**EL18-026 - IN THE MATTER OF THE
APPLICATION BY PREVAILING
WIND PARK, LLC FOR A PERMIT OF
A WIND ENERGY FACILITY IN BON
HOMME COUNTY, CHARLES MIX
COUNTY AND HUTCHINSON
COUNTY, SOUTH DAKOTA, FOR THE
PREVAILING WIND PARK PROJECT**

**APPLICANT’S RESPONSES TO
STAFF’S FIFTH SET OF DATA
REQUESTS**

Figure D-1
 Prevailing Wind Park
 Sound Level Contours

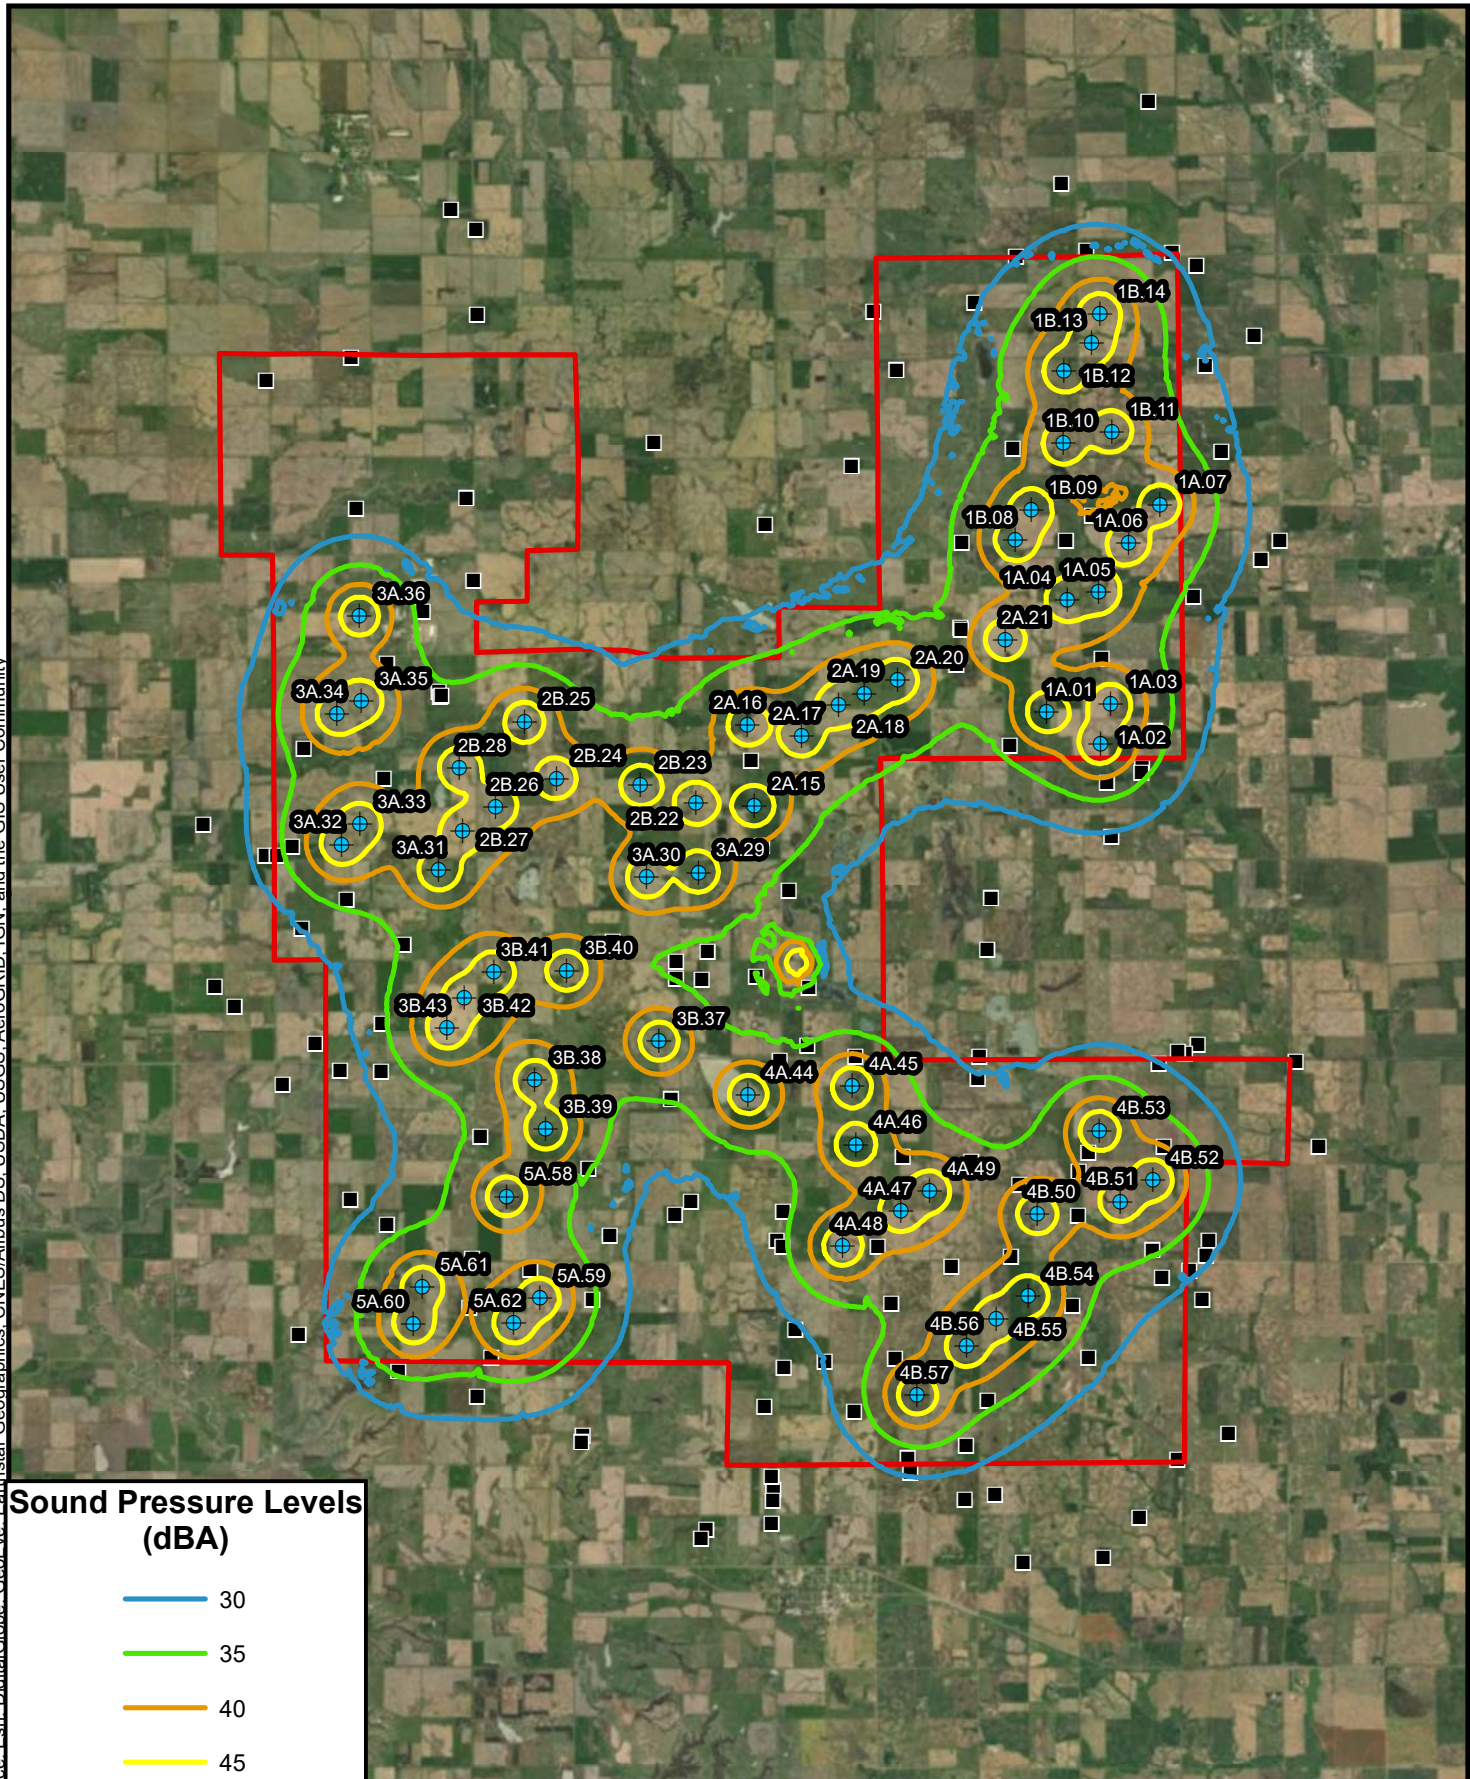
- b) Please submit a map that shows the contour lines for 30, 35, and 40 dBA using the sound model results that the Applicant believes accurately reflects predictive sound levels.

Chris Howell: See Attachment 5-4
